Metro Martin Place

Over Station Development Design Integrity Report

North Site

JUNE 2020

Figure 1 – Comparison of DA approved and proposed Level 10 eastern external terrace arrangement

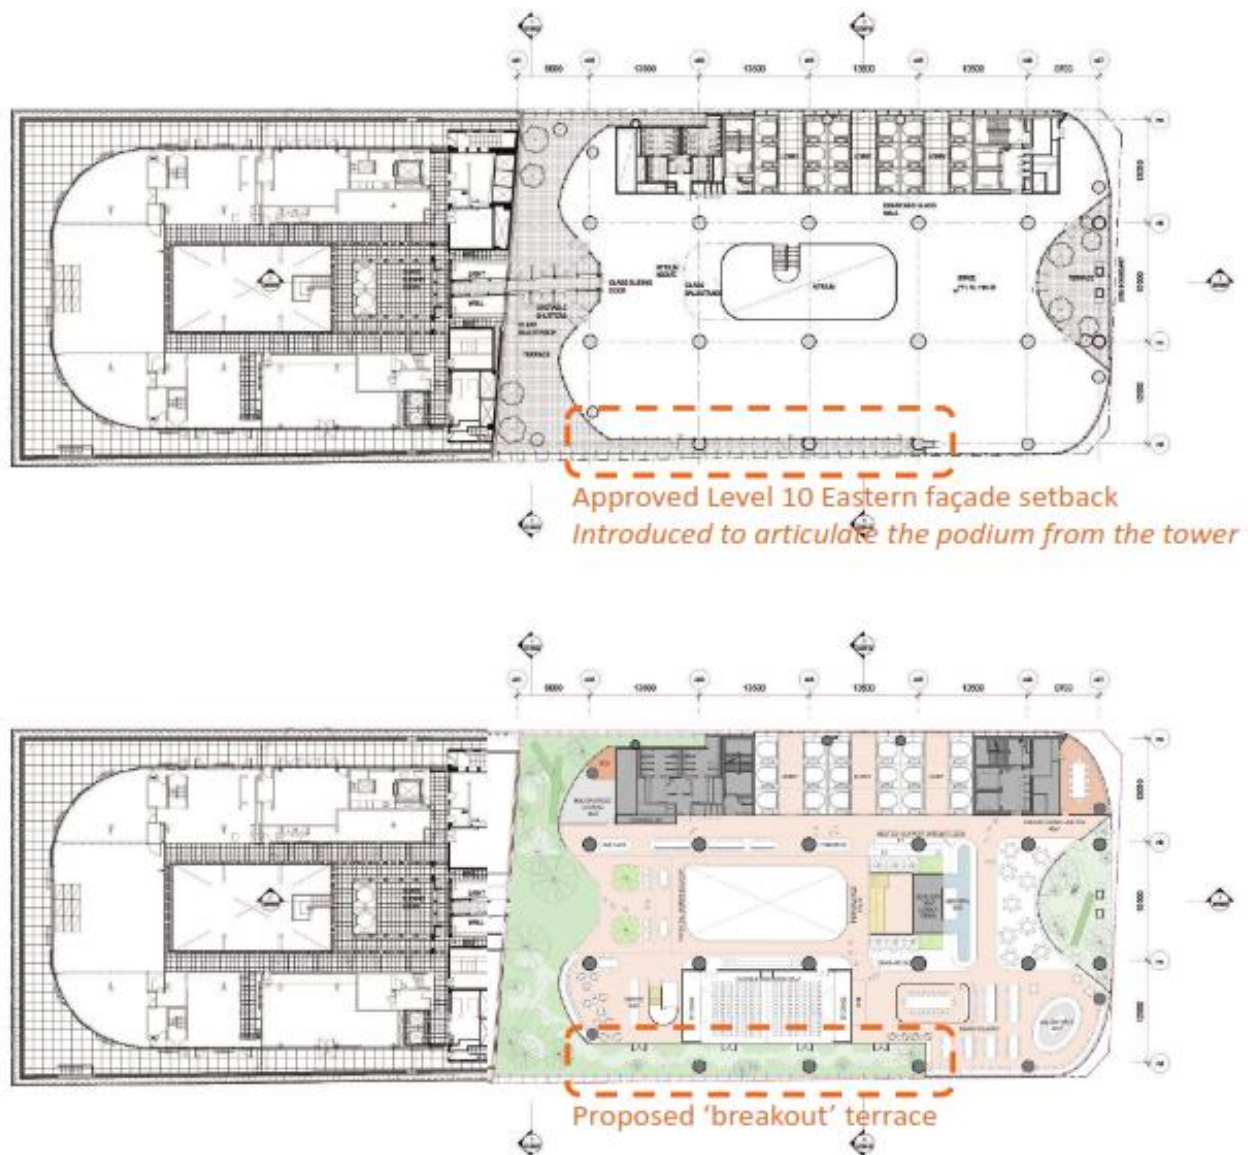
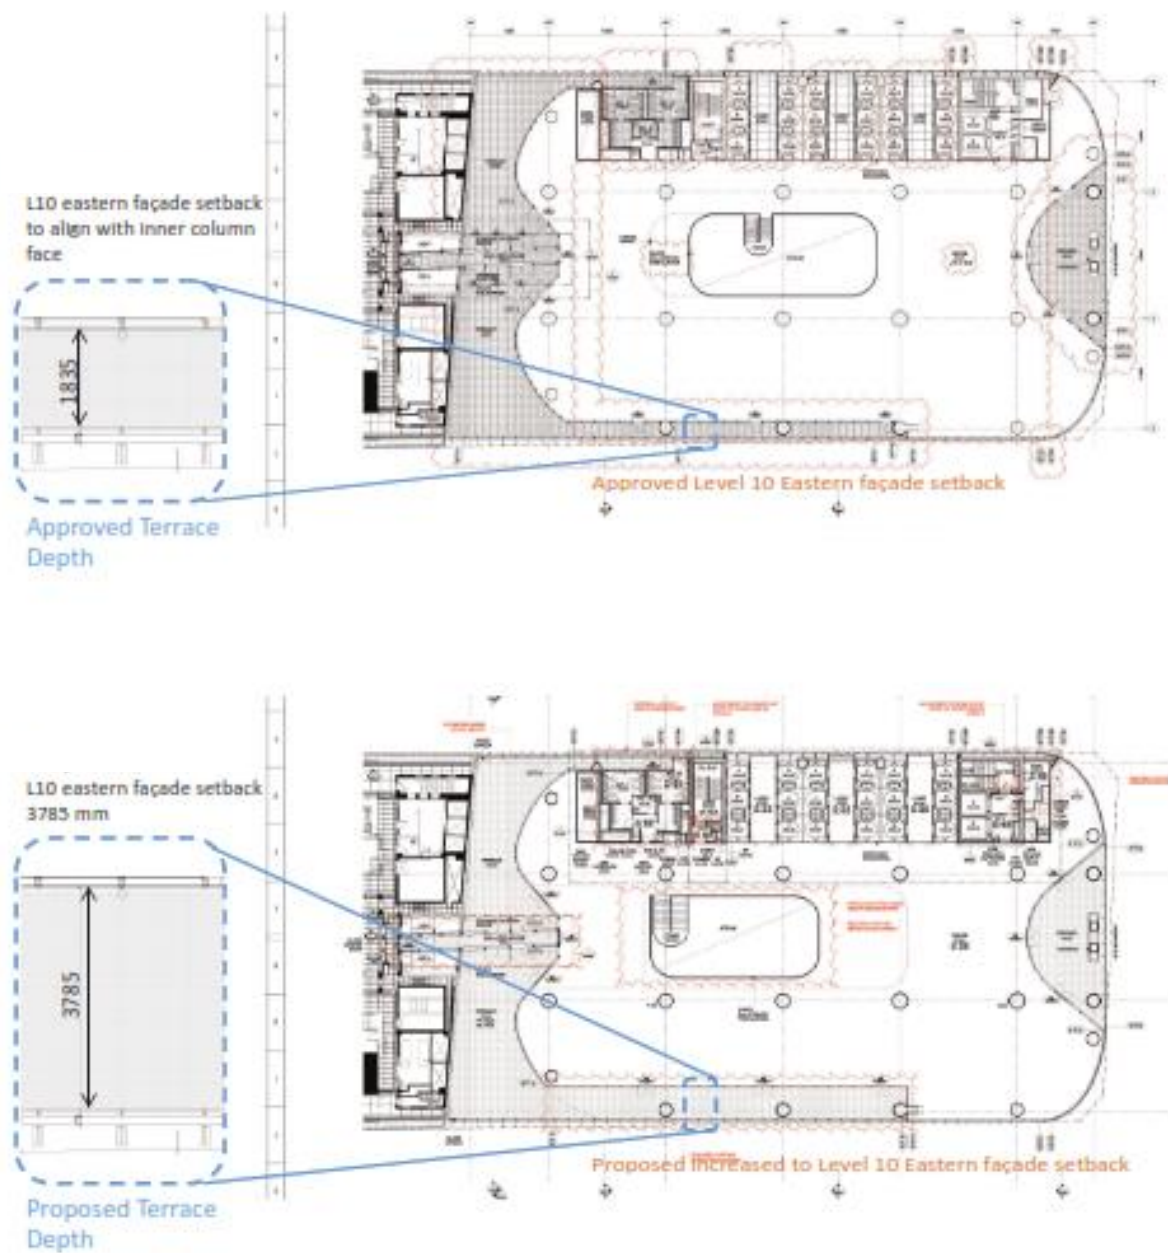
The Level 10 eastern external terrace is currently approved to be 1,835mm wide. The terrace depth is proposed to be widened to 3,785mm, representing an increased width of 1,950mm.

The increased eastern external terrace will facilitate an enlarged space with greater amenity, a more generous outdoor space, and a strengthening of the street wall of Elizabeth Street through a deeper recess.

The detailed design of L10 has identified this terrace as a suitable breakout space. Accordingly, the depth of the terrace is proposed to be increased from 1,835mm to 3,785mm. A landscape proposal which supports the use of the terrace as a breakout space is being developed.

The panel supports the change, noting the positive impact to the approved project.

Proposed Terrace
Depth

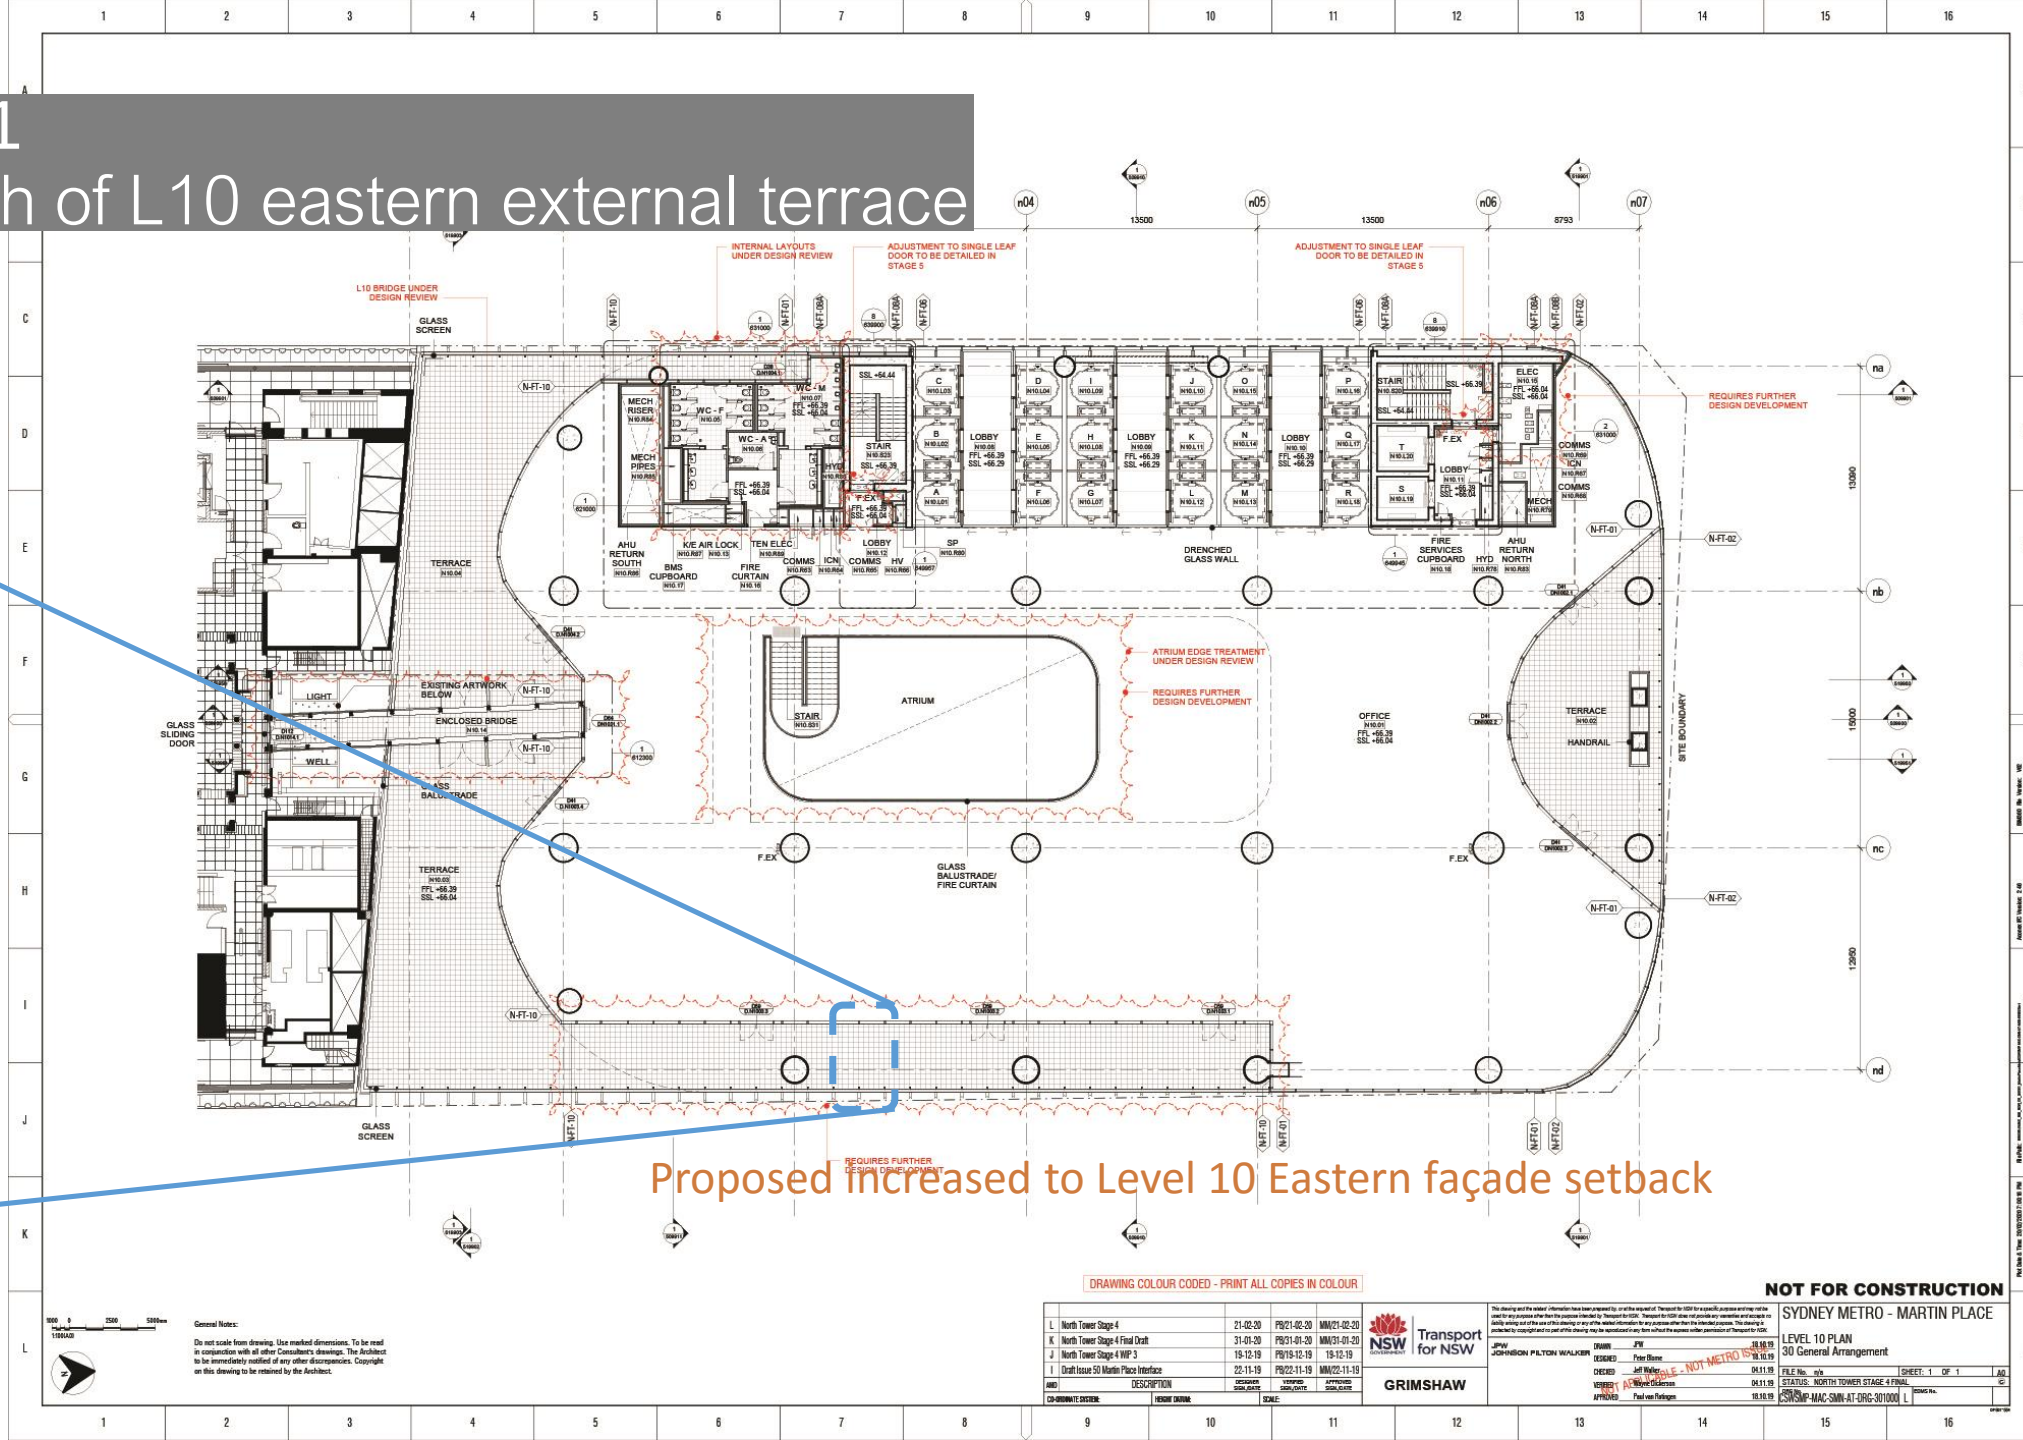
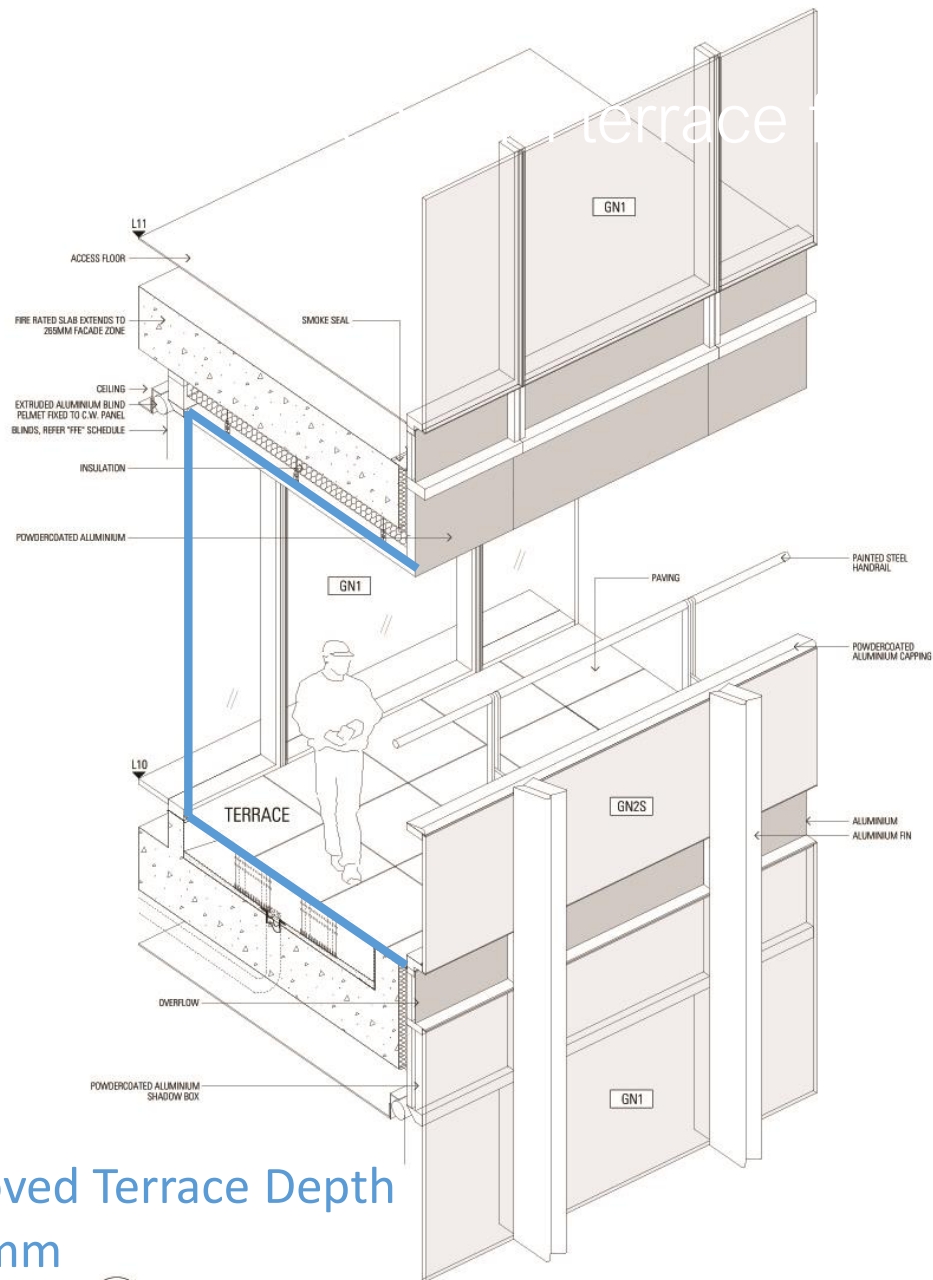
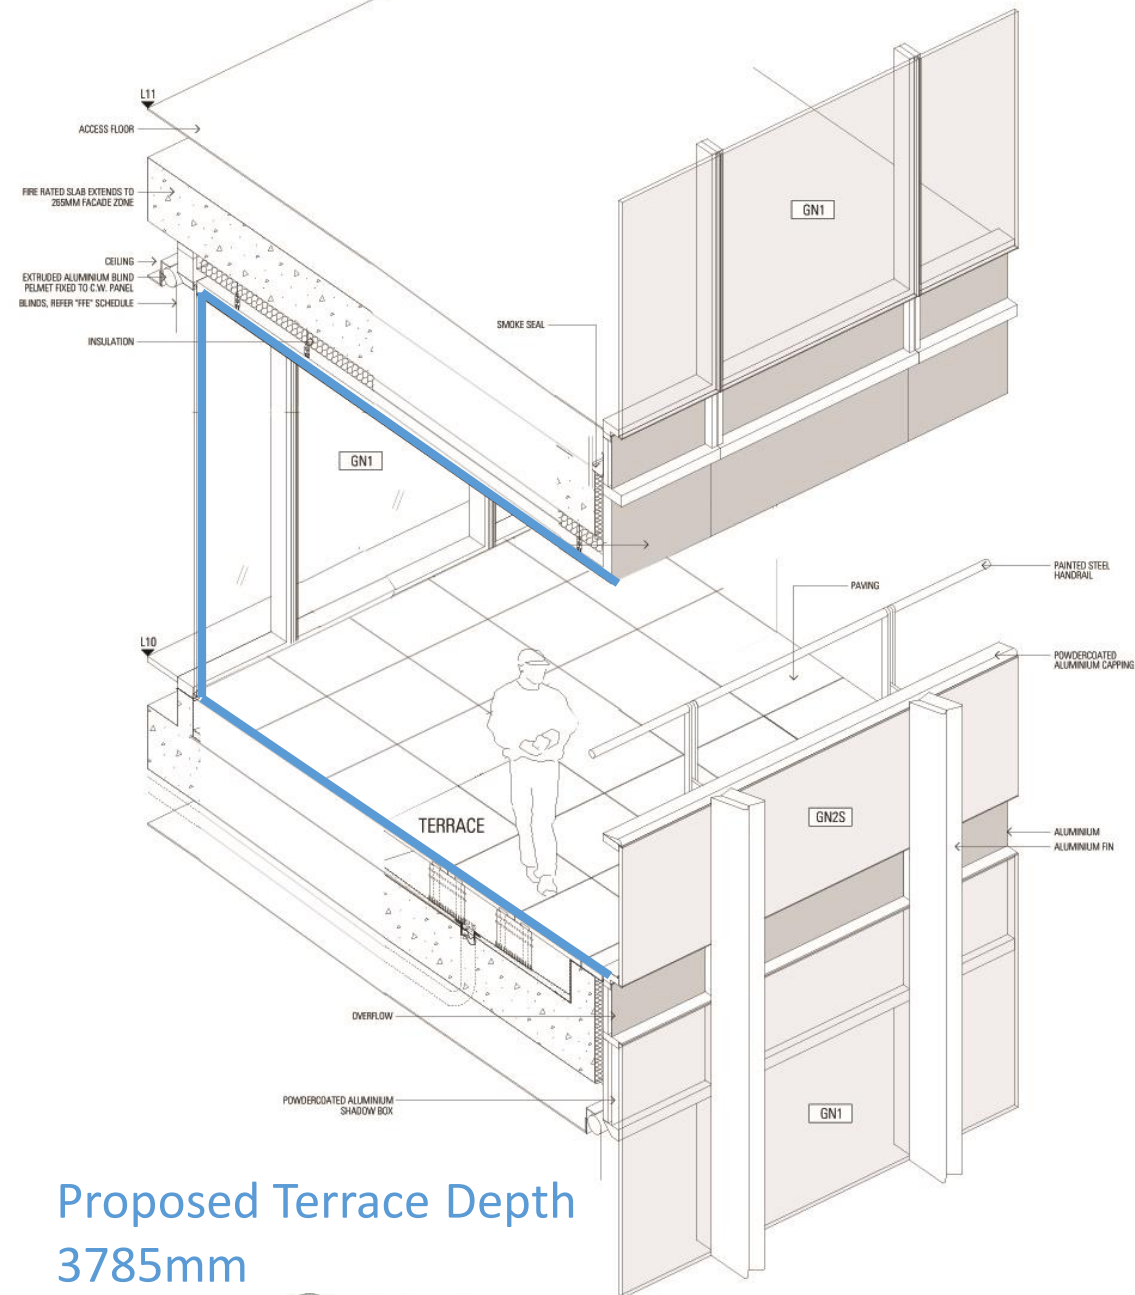
Proposal
L10 eastern façade setback
3785 mm

Modification 1 - increase depth of L10 eastern external terrace

L03 Current Configuration – Floor/Façade Junction (L04 Similar)

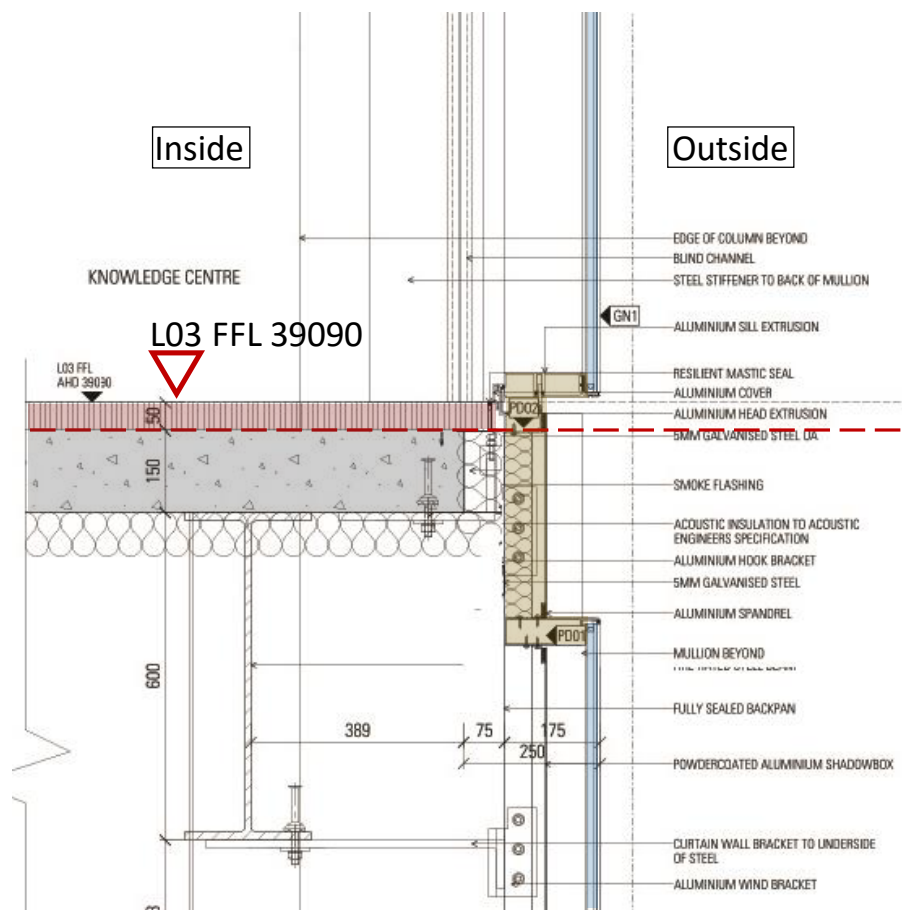
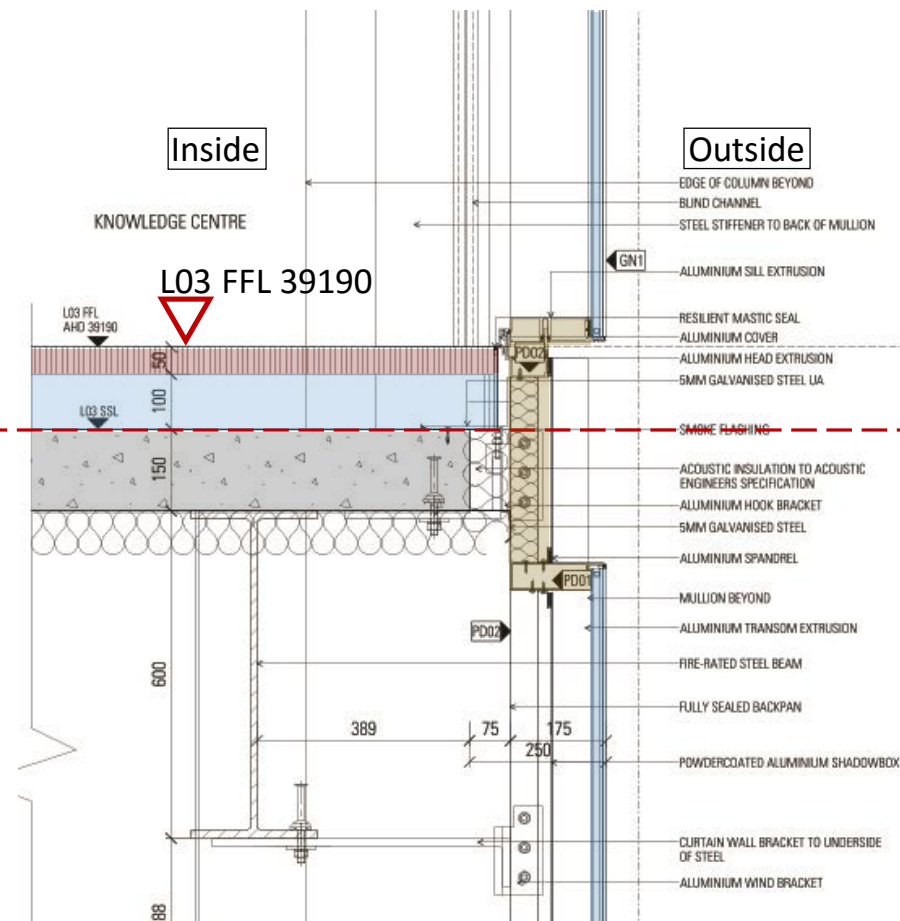
A minor increase in the spandrels on Levels 3 and 4 of the eastern, northern and western facades of the building are proposed to be increased. This amendment responds to the outcomes of a servicing review, which recommended an increase in the floor finishes zone on these Levels 3 and 4 by 100mm. The additional floor finishing requires an increase in the height of the transom, and a subsequent increase in the height of the spandrels on Level 3 and 4. The increase is not discernible in the context of the overall façade. Figures 5 and 6 illustrate the approved and proposed terrace.

L3 and L4 of the North Tower will be a knowledge centre. The FFL of these floors is proposed to be raised by 100mm to provide service access and enable a flexible fit out.

To ensure the internal change has no significant impact on the façade, the position of the stacked joint between the skirt and L3, and L3 and L4 will be raised by 100mm.

The panel supports the change, noting there is no discernible impact to the approved project.
